SERVICE BULLETIN

SV 09- 002

Product: All 2009 WS and GBH shipped from factory prior to Feb. 2, 2009.

Re: Reel arm lock bar.

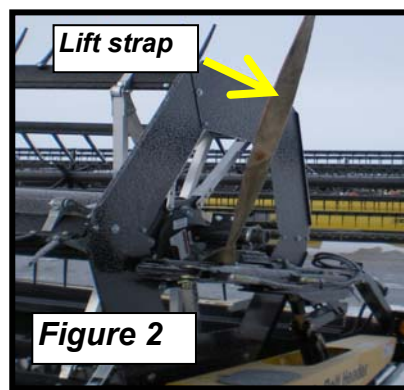
Problem: Due to improperly manufactured parts the reel arm lock bar cannot be placed in lock position.

This is considered a safety issue by Honey Bee Manufacturing Ltd. and all non conforming part must be replaced immediately.

G67229 Incorrect

P81619 Correct

Notice that the correct part has been cut with a radius to clear the cylinder yoke.

Solution: Replace incorrect part with correct part as per photo below.

Parts Required: **P81619** - Reel Lift lock bar - Qty 2.
 70050 - Decal - Warning cyl. Lock - Qty 2.
